PERFORMANCE SPECIFICATION SHEET

EARPHONE ELEMENT,
HIGH AND LOW-ALTITUDE, H-143/AIC
AND LOW-ALTITUDE, WATER-IMMERSIBLE, H-143A/AIC

This amendment forms part of Specification Sheet MIL - PRF-25670/2A, dated 30 May 1997,
and is approved by all Departments and Agencies of the Department of Defense.

MIL-PRF-25670/2C
AMENDMENT 1

FIGURE 4. 25,000 ft. frequency response envelope for earphone H-143/AIC.

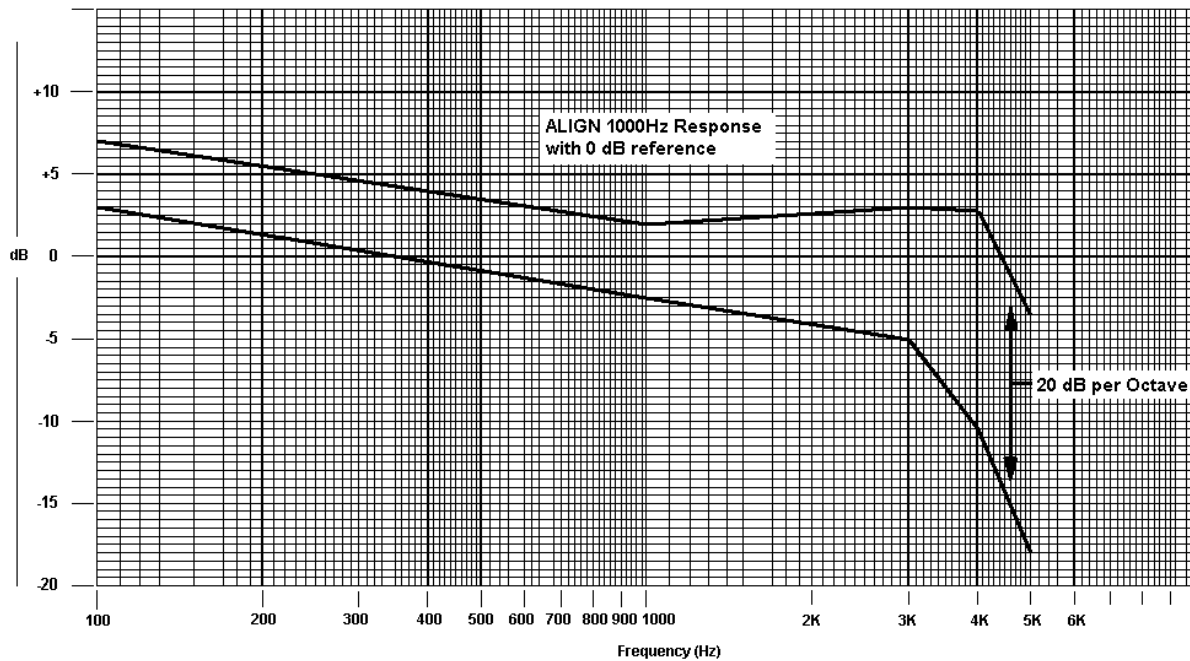
FIGURE 4. Delete and substitute the following:

TABLE II. Key points for 25,000 ft. altitude. (Figure 4)

FIGURE 4. 25,000 FT FREQUENCY RESPONSE KEY BREAK POINTS DIGITIZED.					
FREQUENCY POINTS	100 Hz	1,000 Hz	3,000 Hz	4,000 Hz	5,000 Hz
UPPER LIMIT dB	+7.0	+2.0	+3.0	+2.75	-3.50
LOWER LIMIT dB	+3.0	-2.50	-5.0	-10.50	-18.00
